NextEra Energy Transmission West and Pacific Gas and Electric Company

Estrella Substation and Paso Robles Reinforcement Project

Proponent's Environmental Assessment (A.17-01-023)

Response to Deficiency List No. 4

Exhibit 4-3.1a: Single Line Diagram for Templeton Substation Expansion, Option 1

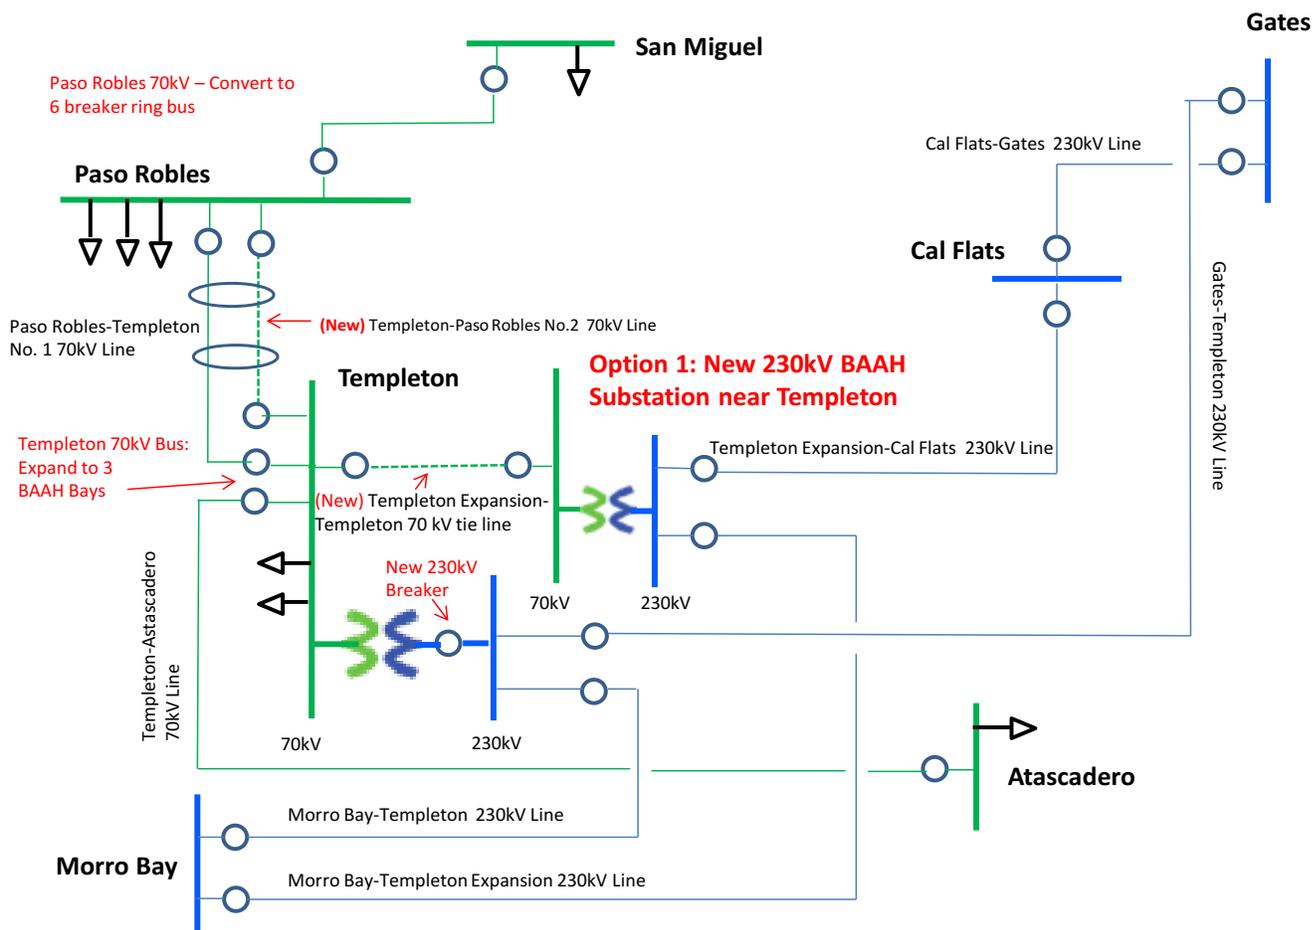
In addition to updating the table, explain whether the replaced 70-kV line would be double or single-circuit and why.

Discuss the extent to which each routing option would meet the identified NERC violations that are mandatory to address (i.e., Category B contingency due to loss of either the Templeton 230/70 kV #1 Bank or the Paso Robles-Templeton 70 kV Line).

Explanation whether the replaced 70 kV line would be double or single-circuit: To address the two Category B contingencies for thermal overloads and voltage concerns within the Paso Robles Distribution Planning Area (DPA), it would be necessary to convert the existing Templeton-Paso Robles 70 kV line to a double-circuit pole line. One of the purposes of this project is to improve reliability by having another 230 kV source introduced into the local area 70 kV system and providing Paso Robles Substation with an additional power flow path. The existing Templeton-Paso Robles 70 kV line is currently being fed through an existing 230/70 kV transformer at Templeton Substation. This transformer is connected to the Templeton-Gates and the Morro Bay-Templeton 230 kV transmission lines. An additional 230/70 kV transformer can be supplied by looping the Gates (now Cal Flats)-Morro Bay 230 kV transmission line through a new 230 kV substation adjacent to Templeton Substation. A new 70 kV breaker and a half (BAAH) yard would be built on the north end of the Templeton Substation and connected to both the existing 230/70 kV transformer and the new 230/70 kV transformer at the new substation. A second transmission line would then travel from the 70 kV BAAH yard to Paso Robles Substation where it would connect to a reconfigured 70 kV ring bus at Paso Robles. Because this option conceives of using the existing Templeton-Paso Robles 70 kV alignment, a second 70 kV circuit would have to be added and convert the existing single-circuit 70 kV line to a double-circuit 70 kV line. This second 70 kV line would provide an additional power flow path from Templeton Substation to Paso Robles Substation in the event of the loss of the existing Templeton-Paso Robles 70 kV power line, the loss of the existing Templeton 230/70 kV transformer, or the loss of the Templeton-Gates 230 kV and the Morro Bay-Templeton 230 kV transmission lines (see Exhibit 4-3.1a, Single Line Diagram for Templeton Substation Expansion, Option 1).

A shoo-fly would need to be constructed along the existing Templeton-Paso Robles 70 kV route to keep Paso Robles Substation energized while a double-circuit Templeton-Paso Robles line is constructed. Currently Paso Robles Substation has five 70 kV connections (or elements) connected to a single bus: three connections to the existing distribution transformers; one connection with the 70 kV line to San Miguel Substation; and one connection with the 70 kV line from Templeton Substation. Bringing one additional 70 kV line into Paso Robles Substation would increase the number of elements on the 70 kV bus to six, which requires expansion of the existing single bus at Paso Robles to a ring bus per Attachment 4-3.1b, PG&E Design Criteria #073131 – Bus Configuration.

Option 1 – Templeton Expansion - New Substation located across from Templeton Substation. New single 70 kV circuit from Templeton Substation to Paso Robles Substation with Paso Robles 70 kV bus converted to a ring configuration. (See Exhibit 4-3.1a, Single Line Diagram for Templeton Expansion Option 1).

- P1 (Templeton-Paso Robles 70 kV line): The issue is mitigated due to an additional line from Templeton to Paso Robles. However, if the line is on the same poles, a single pole failure would result in the loss of both lines and would have the same effect as today.
- P1 (Templeton 230/70 kV Bank No. 1 & Templeton 230 kV bus): These issues are mitigated due to the additional, new 230 kV BAAH substation located across from Templeton Substation.

- P2 (Templeton 70 kV bus, Templeton 70 kV Circuit Breaker No. 12): These issues are mitigated due to the installation of a 70 kV BAAH yard at Templeton Substation.

Exhibit 4-3.2a: Cost Magnitude of Proposed Estrella Projects Compared to Templeton Substation Expansion Alternatives

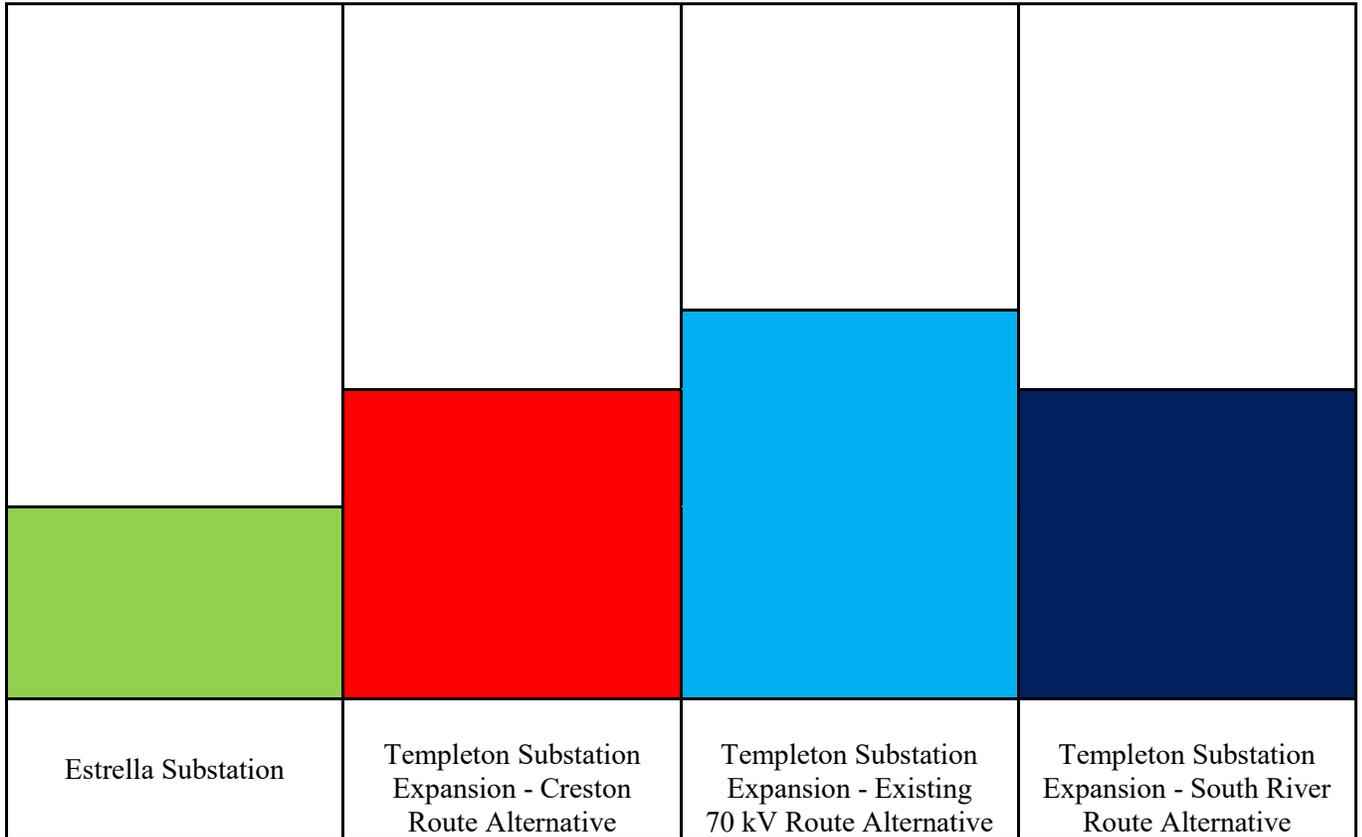
Please resubmit the 8/28/17 response to 4-3(A) in a public format. Confidential cost information may be submitted separately as needed. This alternative will be disclosed to the public during the CEQA review process.

Please update the response submitted sufficiently to evaluate the Templeton Expansion Alternative in the EIR, including enough detail to determine if it would meet most of the basic project objectives; be feasible; and have less environmental impact than the proposed project. An environmental analysis will be completed on this alternative and documented in the EIR, including the two 70-kV routing alignments between Templeton and Paso Robles. In addition to the two alignments already provided, provide an alignment that assumes only the existing Templeton-Paso Robles 70-kV ROW would be used or would be used with minimal expansions as required. Shoo-fly line use should also be discussed as needed and an alignment(s) provided.

Although the detailed cost information is confidential, the applicants believe it would be helpful to show the relative estimated cost magnitude of the proposed Estrella project as compared to the three 70 kV route alternatives associated with the Templeton Substation Expansion alternative. Note that the estimated cost to construct the 230 kV interconnection and the 230/70 kV substation adjacent to Templeton Substation are assumed to be equivalent for the Estrella project and the Templeton Substation Expansion alternative. Accordingly, Exhibit 4.3-2a, Cost Magnitude of Proposed Projects Compared to Alternatives below compares the magnitude of PG&E's estimated costs to construct the proposed project and the listed alternatives. The chart indicates that all three of the Templeton Substation Expansion alternatives would cost substantially more than the proposed Estrella project, and that the Templeton Substation Expansion alternative that would convert the existing single-circuit Templeton-Paso Robles 70 kV line to a double-circuit line would cost the most by far.

Exhibit 4-3.2g: Paso Robles Substation Expansion Alternative

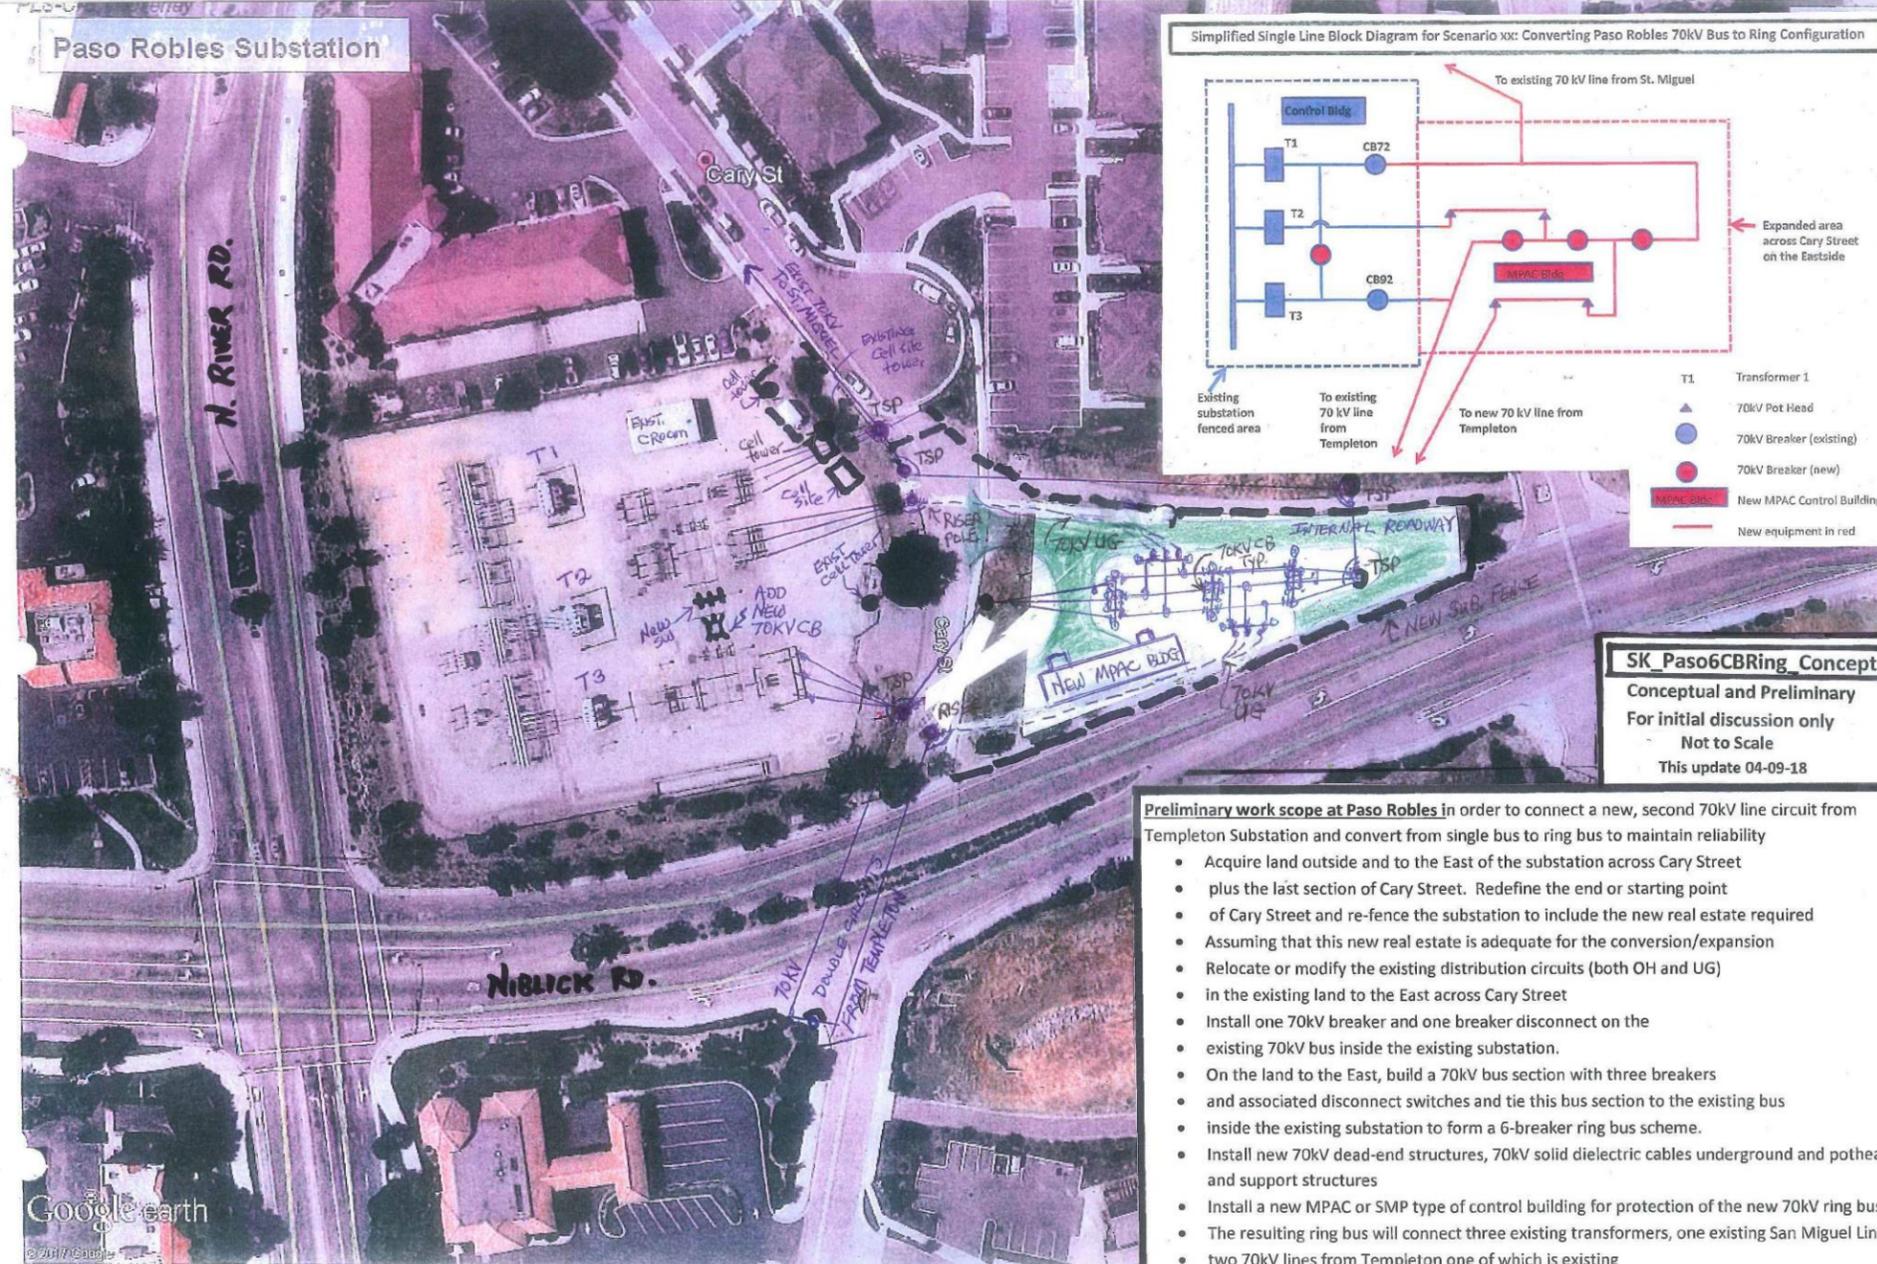
In regard to a question raised, Why a Main and Transfer bus could not be installed inside the existing Paso Robles Substation?; the short answer is that there is not enough space inside the substation to install a transfer bus. A Main and Transfer bus installation still requires an internal roadway on the outside of each bus in order to perform operating and maintenance activities. If a transfer bus was installed in Paso Robles Substation in the area currently occupied by the internal roadway, in parallel with the existing 70 kV bus, and between the 70 kV bus and the substation fence on the east side, there would not be room to create a new internal roadway outside the proposed transfer bus for operation and maintenance. In addition, installing a transfer bus would require the installation of new switching devices, such as a bus tie breaker, to improve the maintenance process by moving the line of the circuit breaker to be maintained to the transfer bus and then protected by the tie breaker. This bus tie breaker would require one additional line breaker bay space, which is not currently available.

Assuming the challenges to utilize the land to the east of Paso Robles Substation could be overcome, a new 70 kV bus section would have to be installed together with three 70 kV breakers and their associated disconnect switches. This new 70 kV bus section would be connected to the existing 70 kV bus inside the current substation and one additional breaker would be added into the existing bus to form a 6-breaker ring bus. See Exhibit 4-3.2g, Paso Robles 70 kV Substation Expansion Alternative, for a layout diagram of the proposed 6-breaker ring bus configuration at Paso Robles Substation.

Exhibit G (3.1)a: One-Line Diagram, Future Estrella Substation Distribution Feeders

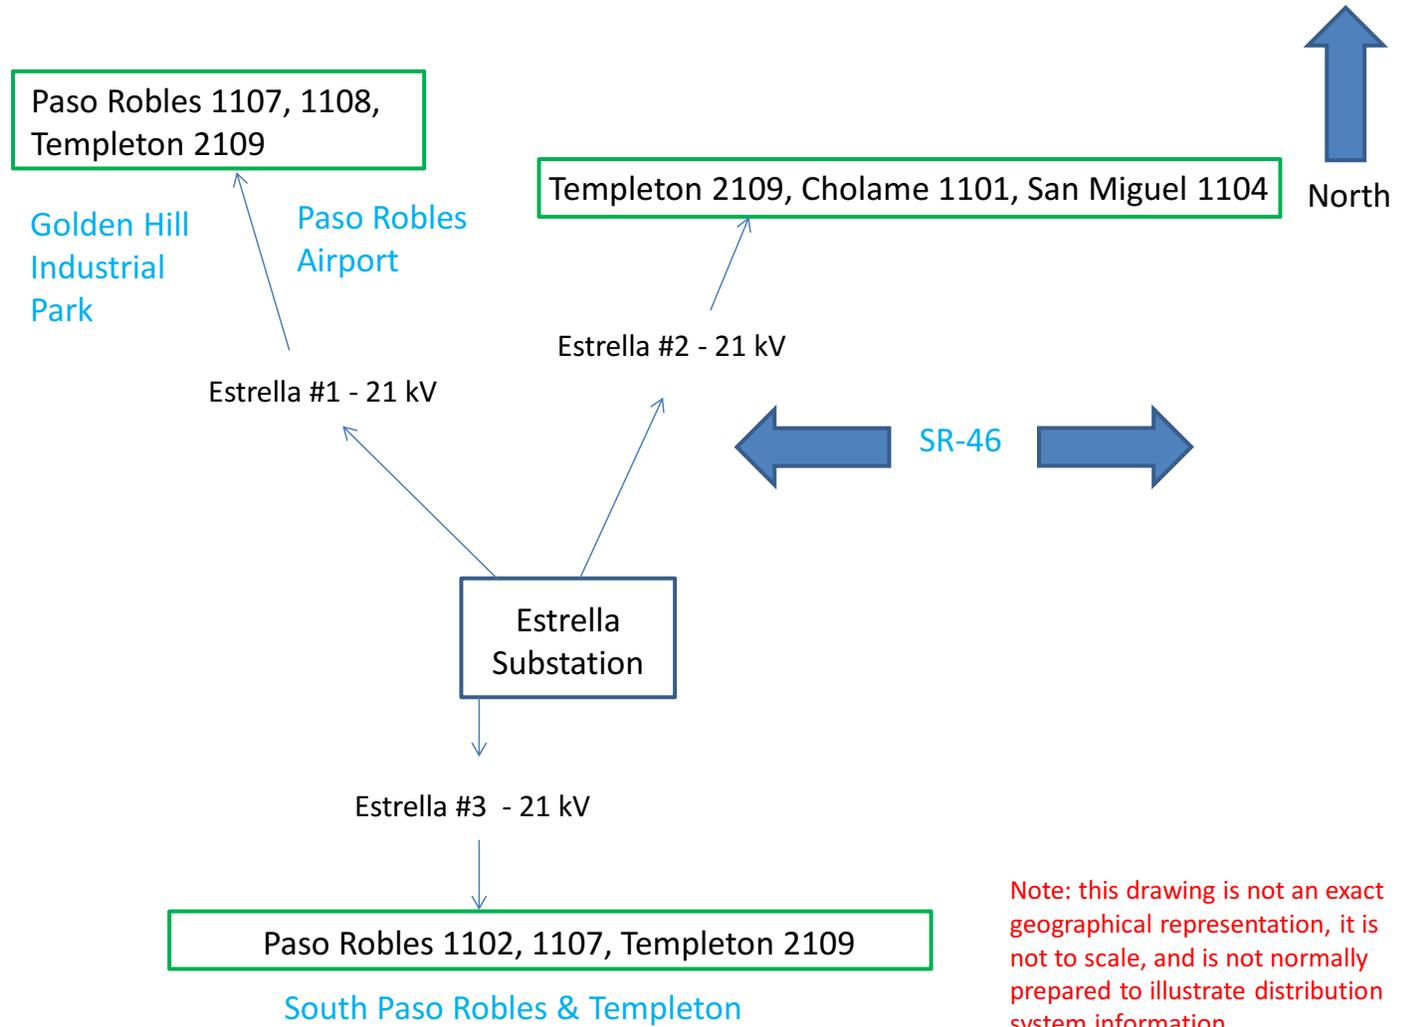
Please provide a one-line diagram and location map as well. Please provide details of how feeders from the proposed Estrella Substation would re-connect to the existing feeders and distribution points. Include powerflow data for 230-kV system serving the area.

One-line diagrams are not typically used for distribution facilities. However, we have prepared one in response to this request; it is included below as Exhibit G (3.1)a, One Line Diagram, Future Estrella Substation Distribution Feeders and as Figure 4C in Appendix G.

Exhibit G (7.1)a: Future Estrella Substation Distribution System, Other Future Proposed Projects

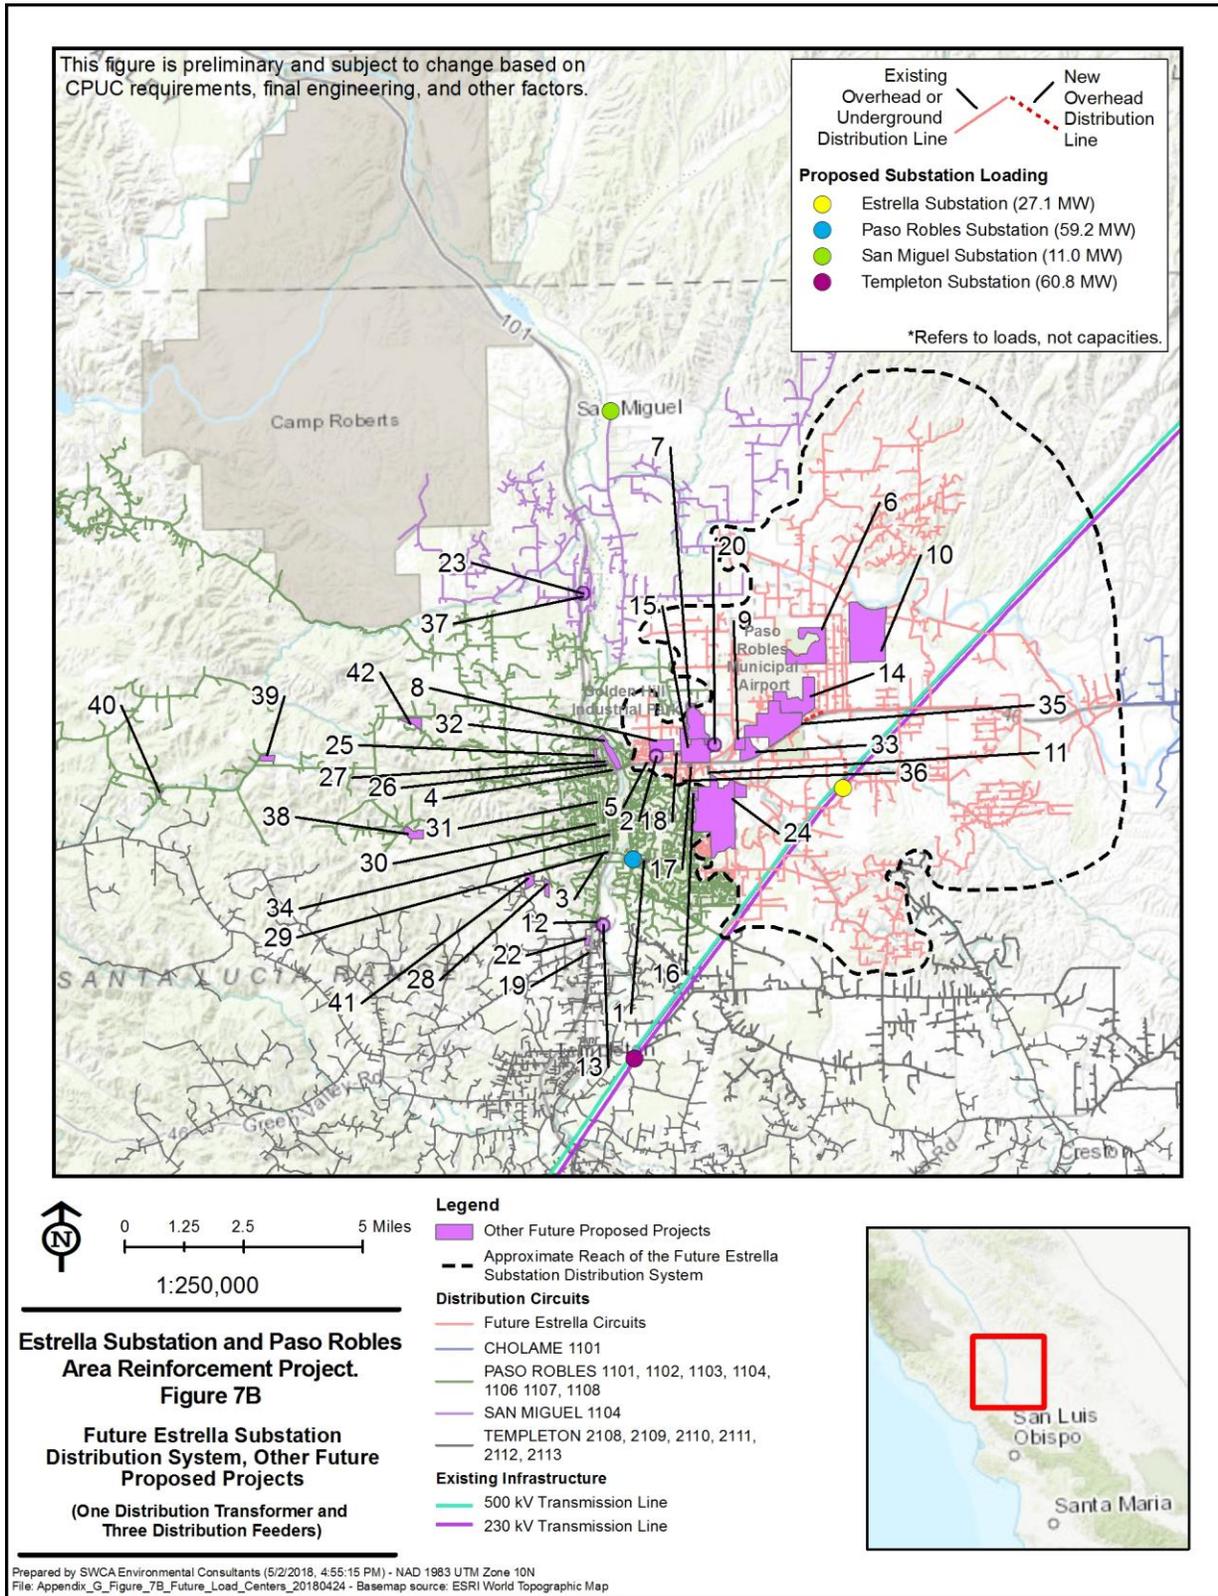
- a. *Several Future Load Centers were removed and a few were added between the prior Figure 7 version and the latest version. Please explain and update Figure 7 as appropriate.*
- b. *In many cases, the locations of Large-Load Adjustments do not occur within or near a Future Load Center. Please explain, and explain how Future Load Centers are defined as opposed to Large-Load Adjustments.*
- c. *Quantify the MW values attributed to each Future Load Center and label them (e.g., Gold Hill and Airport development sites). Provide a table of Future Load Centers similar to the table of Large-Load Adjustments.*

c. See Appendix G, Table 6B. As indicated in Appendix G, Figure 7's reference to "Future Load Centers" should have been "Other Future Proposed Projects"; the figure has been corrected (see Exhibit G ([7.1]a and Appendix G Figure 7B).
